Project #22-006
Blue Spring Business Park Bldg. #1 and #2
Located at approximately 1200 N. 800 W.

<i>Project Name:</i>	Blue Spring Business Park Building #1 and #2
<i>Proponent / Owner:</i>	Andrew Bollschweller / Jason Larsen, Blue Spring Business Park LLC
<i>Project Address:</i>	Approx. 1200 North 800 West
<i>Request:</i>	Design Review Permit
<i>Current Zoning:</i>	Industrial Park (IP)
<i>Type of Action:</i>	Quasi-Judicial
<i>Hearing Date</i>	January 27, 2022
<i>Submitted By:</i>	Tanya Rice, Planner II

Staff recommends that the Planning Commission **conditionally approve** a Design Review Permit for Project #22-006, Blue Spring Business Park Building #1 and #2, in the Industrial Park (IP) zone located at approximately 1200 North 800 West, TIN #05-050-0019.

1 OVERALL NORTH BUILDING ELEVATION
1/16" = 1'-0"

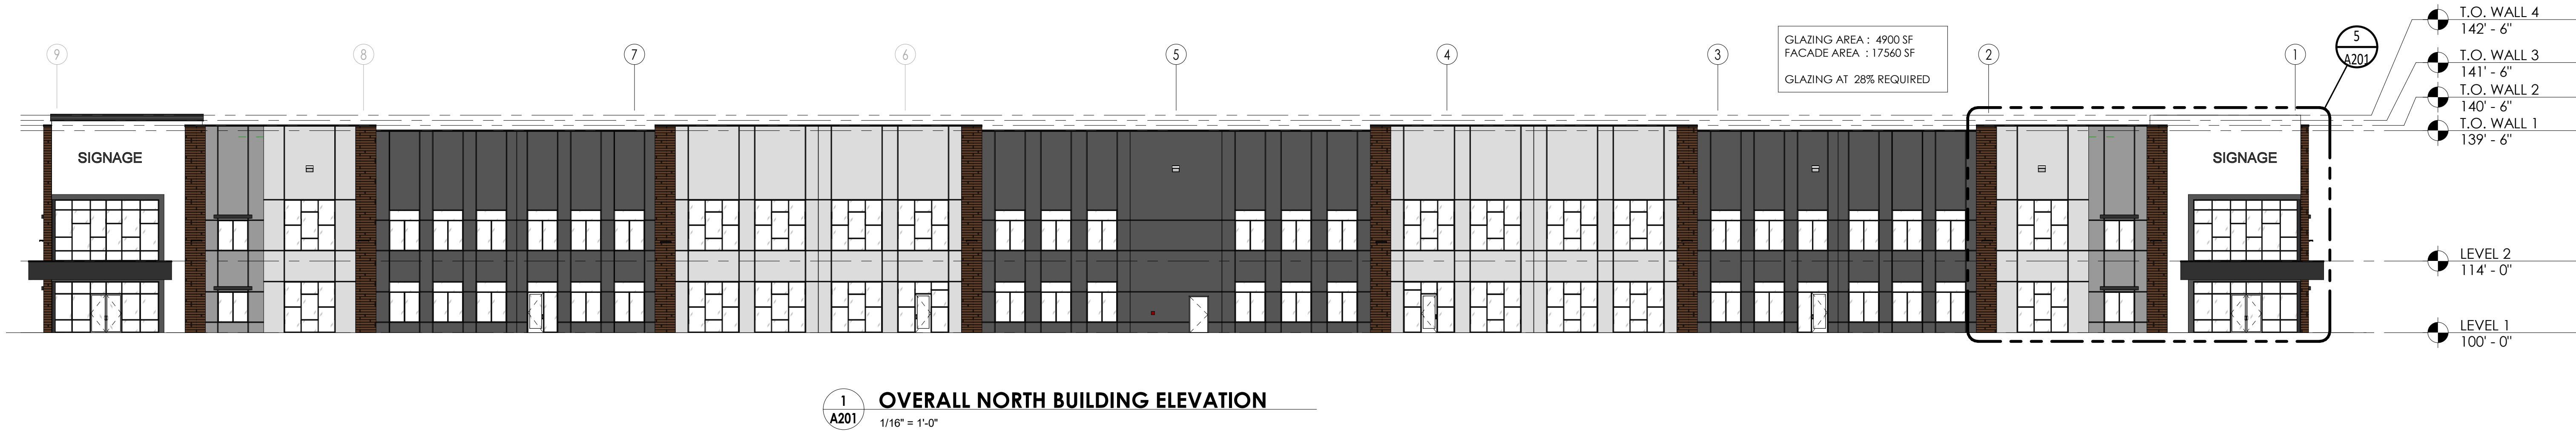
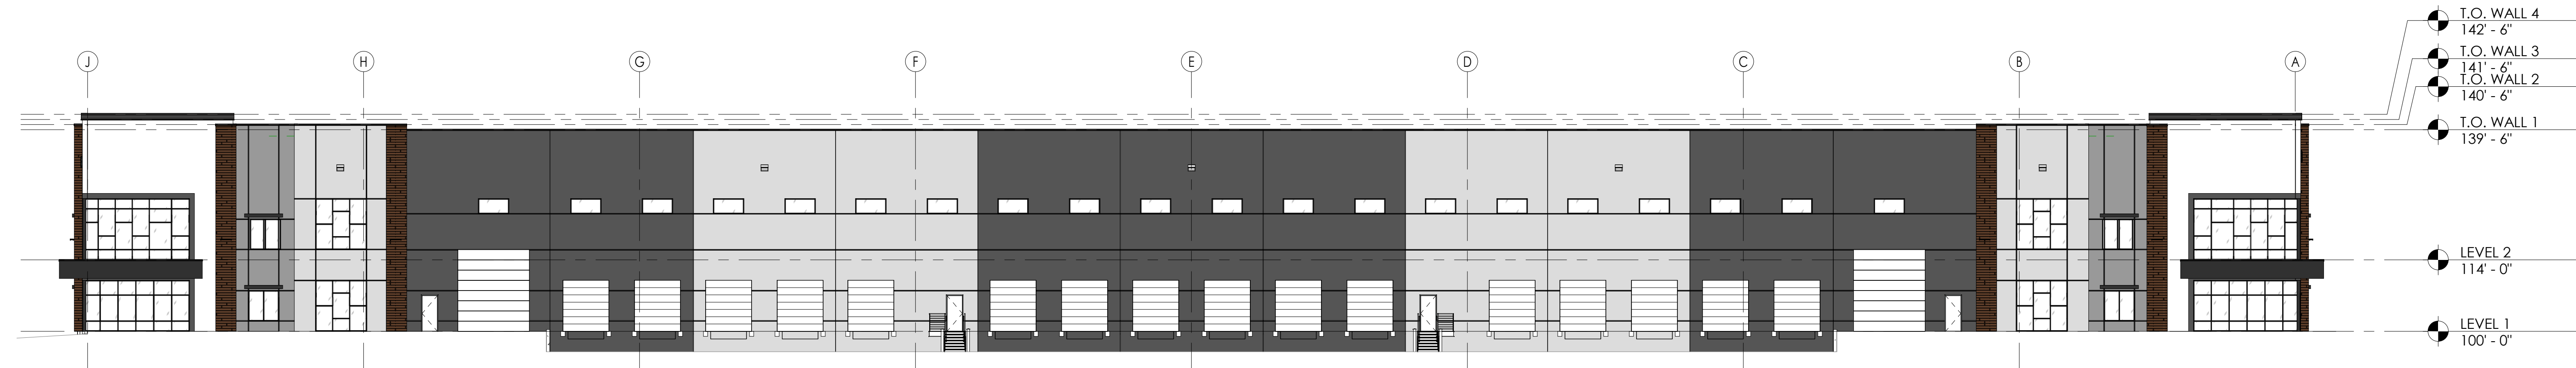
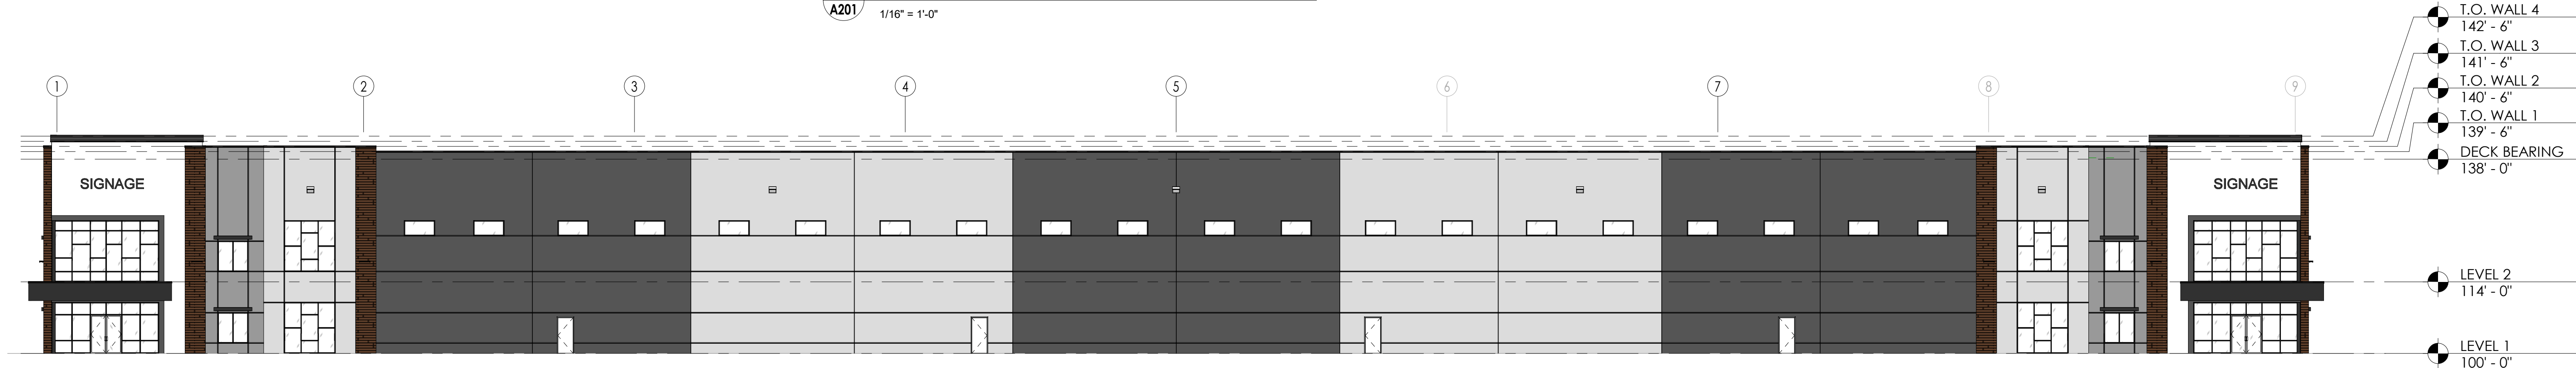
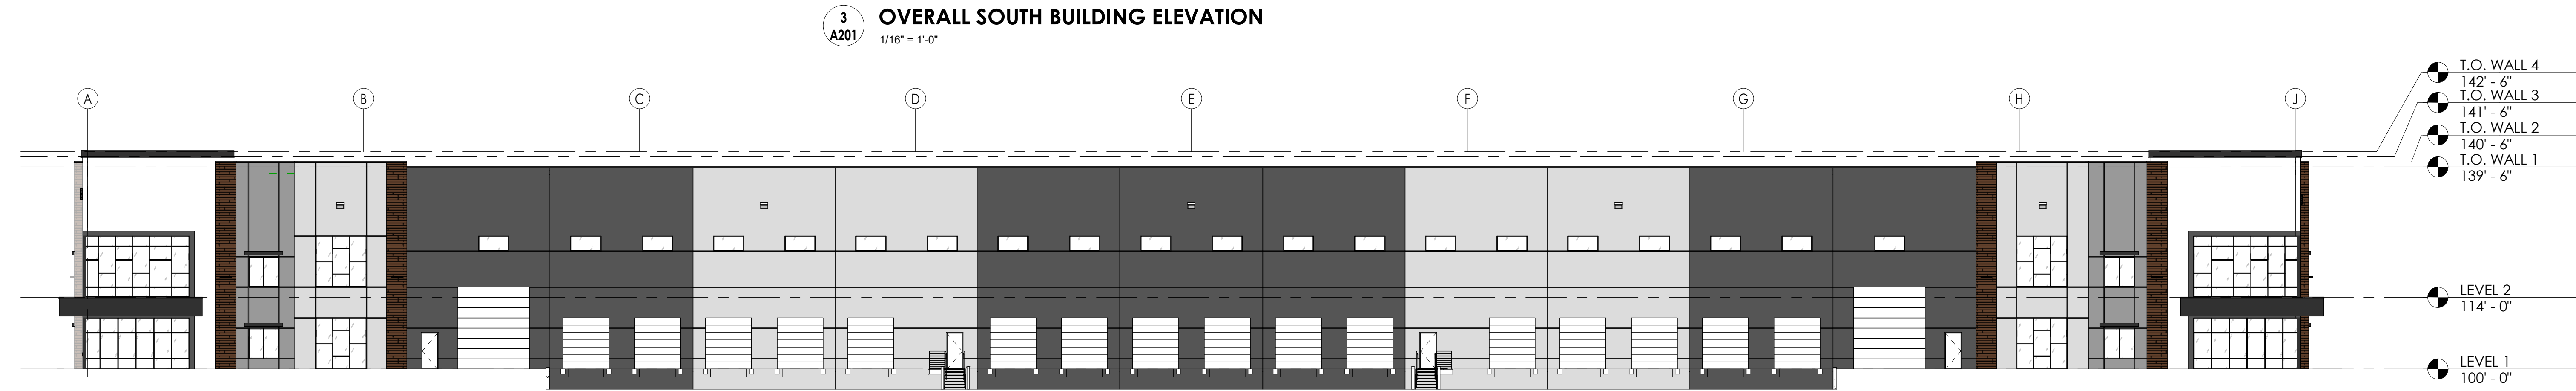
The LDC 17.12.060 requires new industrial buildings to be well-designed with high-quality materials. Blank walls exceeding 40 linear feet are prohibited and ground floor street-facing facades shall have a minimum of 30% transparency. Acceptable wall-breaks include windows, balconies, wall articulation or changes in color and materials. The proposed building materials are tilt-up textured concrete in a variety of earth-toned colors with small vertical accent composite (wood-like) sections. The 1200 North street facing façade is shown with 28% transparency and the 600 West facing façade is shown with 25% transparency, both shy of the

30% LDC standard. The 800 West Street facing façade is shown with 9% transparency (21% fenestration including roll up doors) with the bulk of the façade showing utility doors and entrances. The other non-street facing facades show wall-breaks and other features at the minimum 40 linear foot increments. As conditioned with additional transparency, the building design meets the requirements in the LDC.

3. The Planning Commission utilizes their LDC 17.43.080 approval criteria to adjust the transparency requirement (less than 10% deviation) and approves 28% transparency for both the east and north street facing facades. This is consistent with previous Blue Spring Business Park building approvals.

4. The transparency along the 800 West façade shall increase to 30% unless the Planning Commission utilizes their discretionary design authority and grants a reduction.
